PLANNING COMMISSION
DATE: 6/30/2014
AGENDA ITEM: 4B – PUBLIC HEARING
CASE # 2014-22

ITEM: Village Preserve Residential Subdivision – Preliminary Plat

SUBMITTED BY: Nick Johnson, City Planner

PRELIMINARY EROSION CONTROL PLAN & TREE SURVEY
VILLAGE PRESERVE
GW LAND DEVELOPMENT

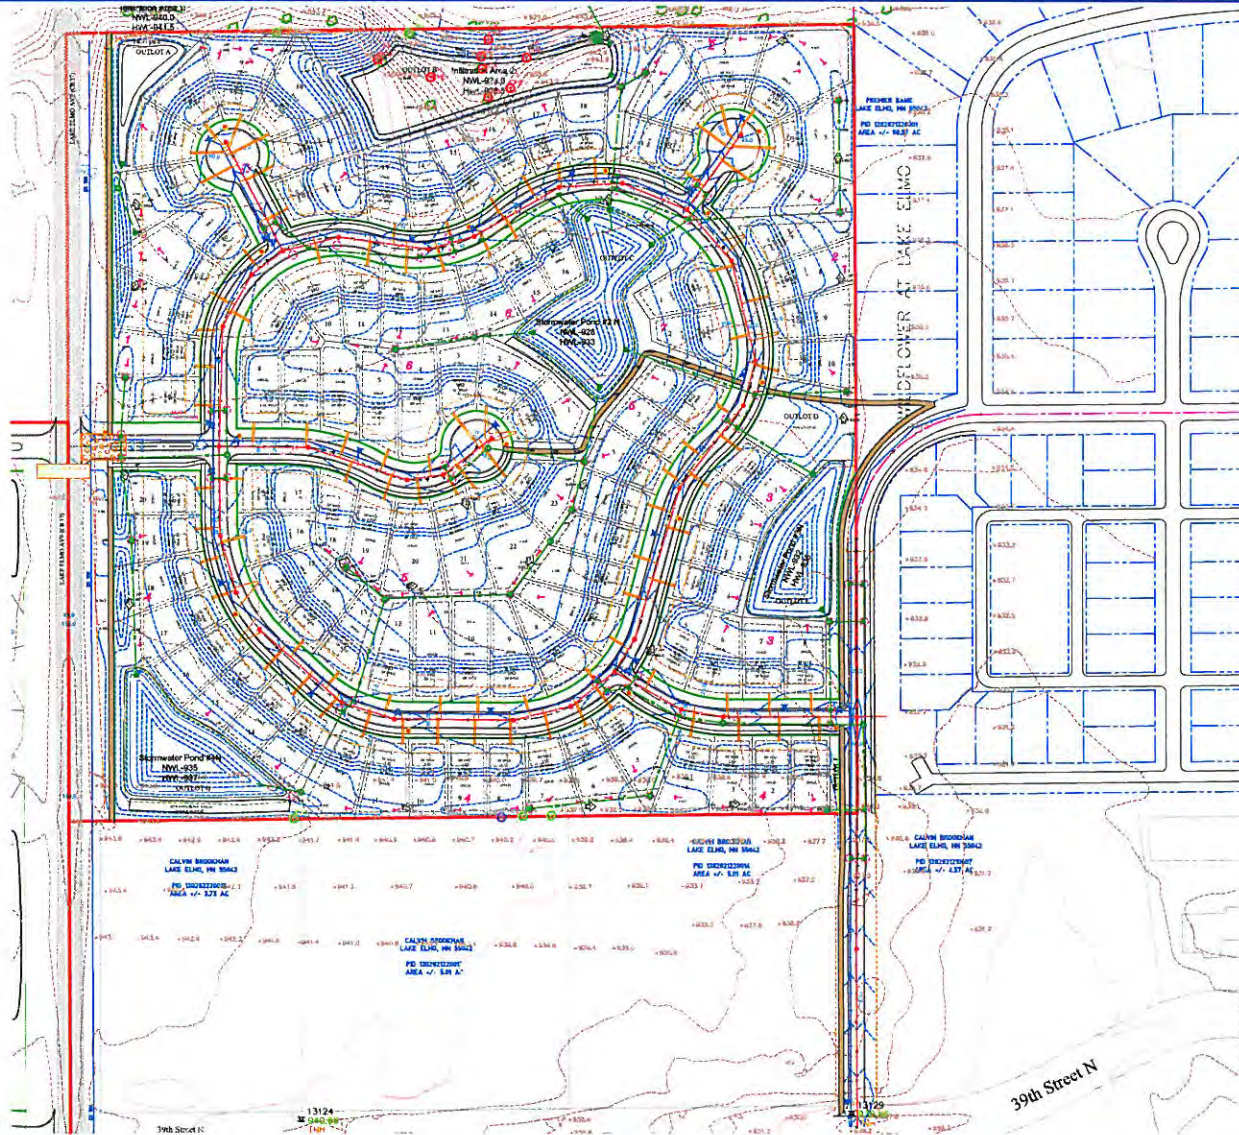
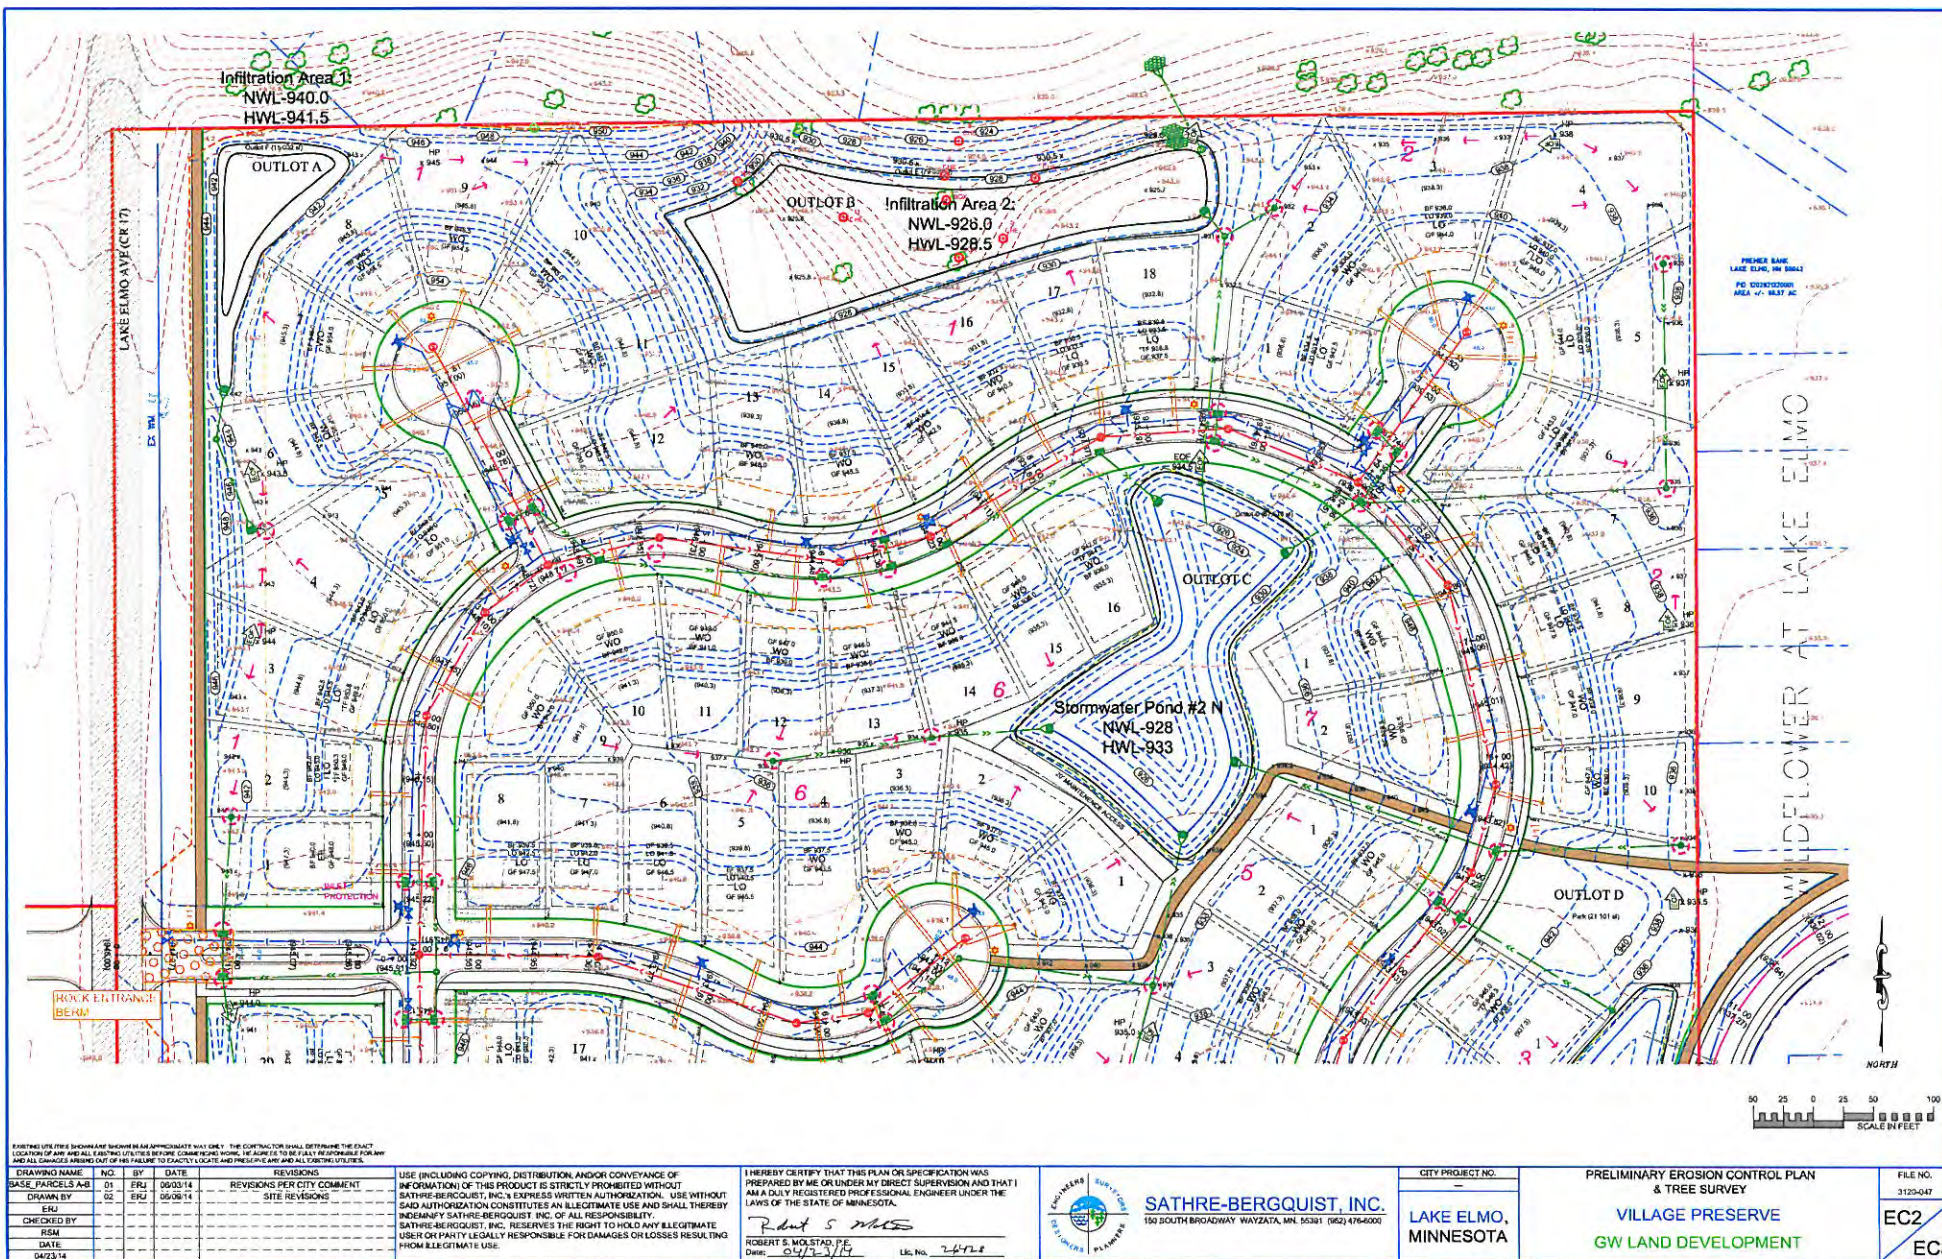
- **Landscaping and Tree Preservation.** The landscape and tree preservation plans have been reviewed by the City's consulting landscape architect, Stephen Mastey. Mr. Mastey's review memorandum related to the landscape and tree preservation plans is found in Attachment #8. Mastey noted that in some cases the boulevard tree spacing is too large. In addition, he is requesting that permanent ground cover and irrigation details be provided in the Final Landscape Plan. Staff is recommending that the Final Landscape be updated per the recommendations of the landscape consultant (Condition #9). In addition, it should be noted that the Tree Preservation information is located on the Erosion Control Plan. Finally, the notes on the Landscape Plan indicate that the tree replacement requirements are being met by the applicant.

- 8) The Landscape Plan shall be updated per the recommendations of the City's Landscape Consultant, describe in a memo dated 6/25/14.
- 9) The developer shall be required to submit an updated parkland dedication calculation in advance of Final Plat to clarify the proposed amount of dedication being provided in the Village Preserve Subdivision. For whatever amount of land the applicant is short of the required parkland dedication amount, the applicant will either:

LANDSCAPE PLAN
PARCEL B
SCHILTGEN FARMS
GW LAND DEVELOPMENT

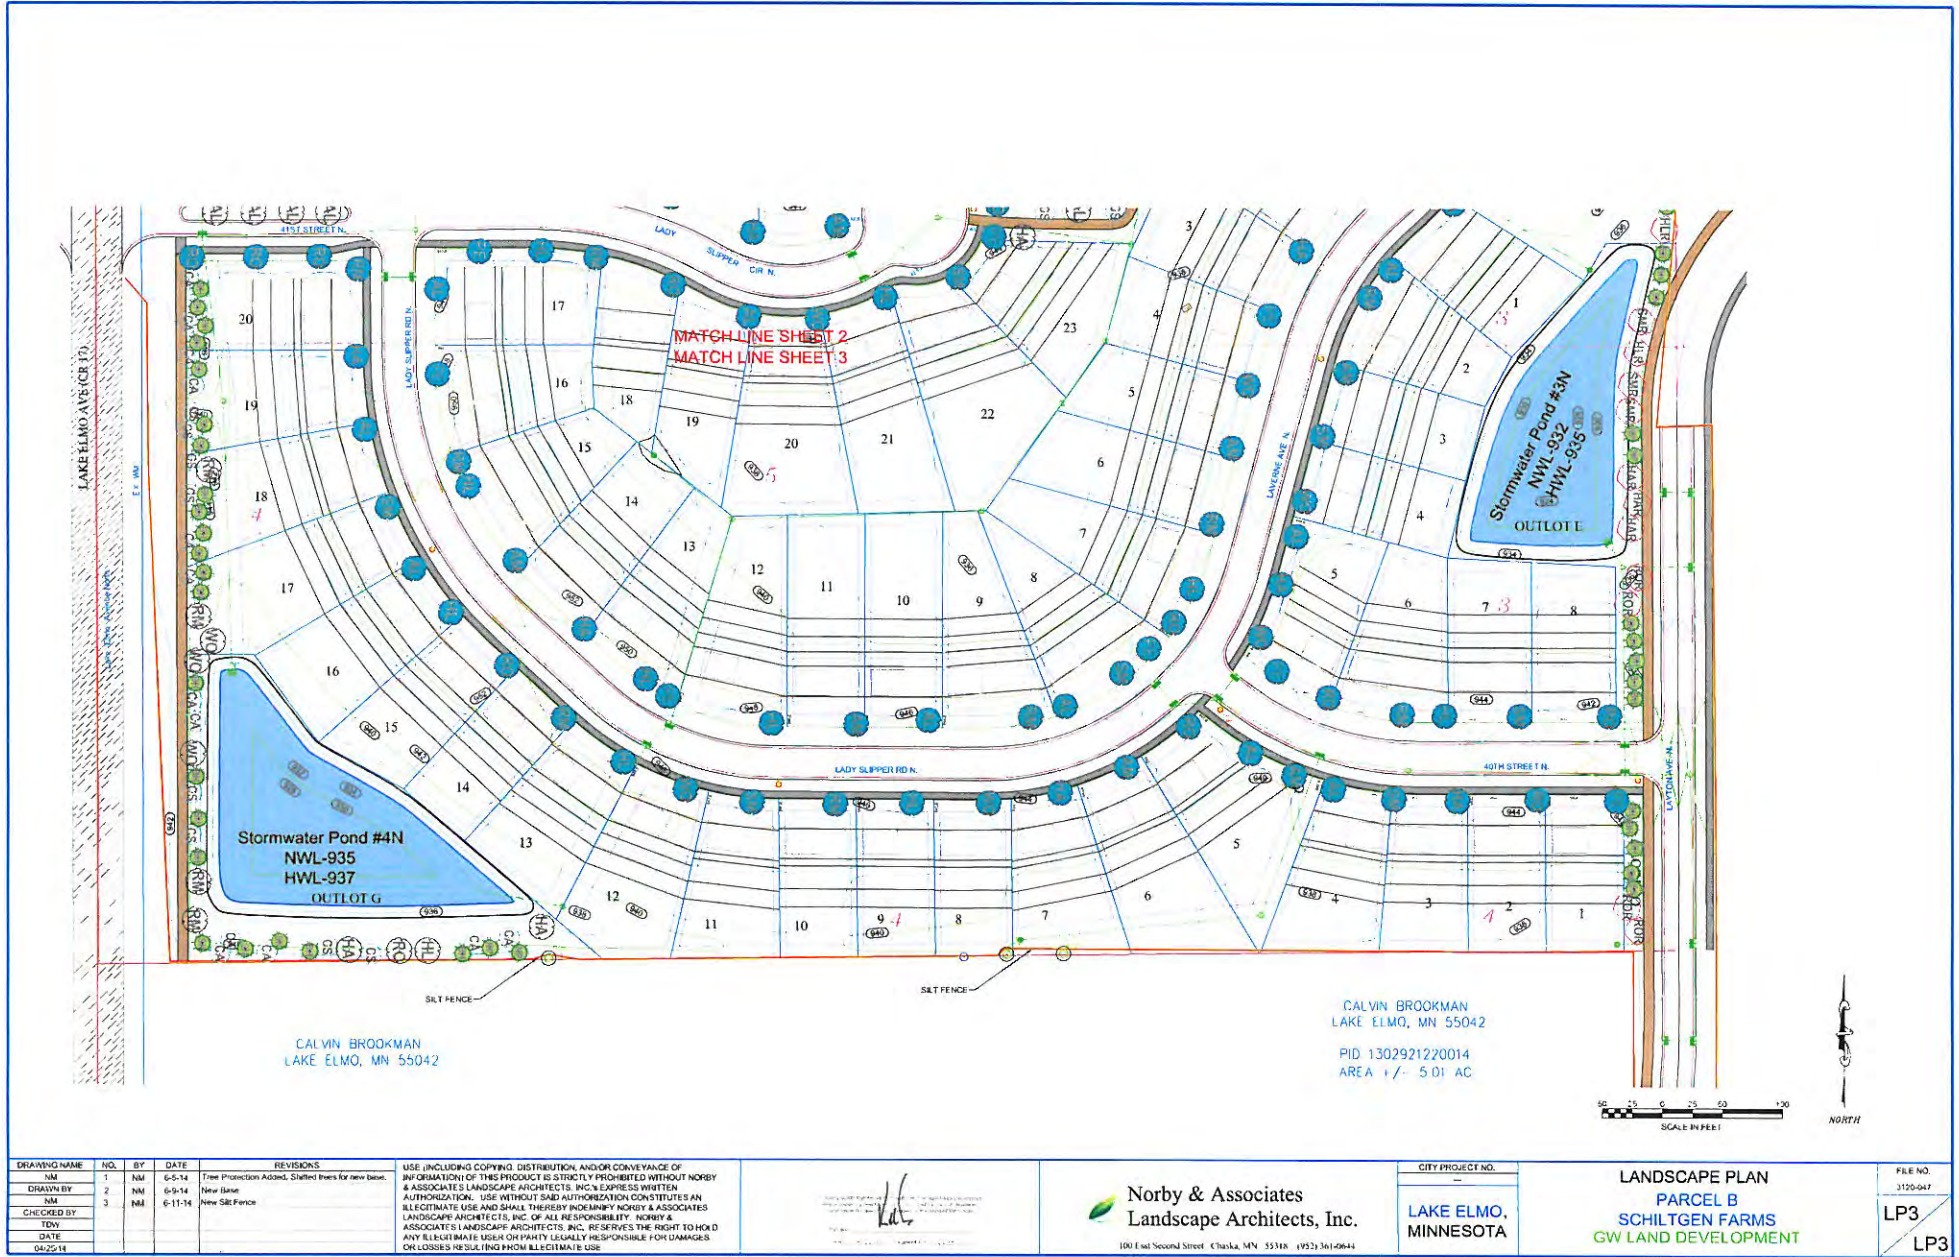
1. Boulevard Trees to be spaced no further than 50 feet on center.
2. See Typical Right of Way Layout – City of Lake Elmo Drawing No. 805 attached to this document for correct boulevard tree layout locations.
3. Please correct plant name spelling errors on sheet LP1.
4. Village Preserve Project Landscape Architect to provide temporary and permanent groundcover vegetation landscape plans for all lots, commonly held HOA & City R.O.W. areas.
5. Village Preserve Project Landscape Architect to provide landscape irrigation plans for all commonly held HOA & City R.O.W. areas.
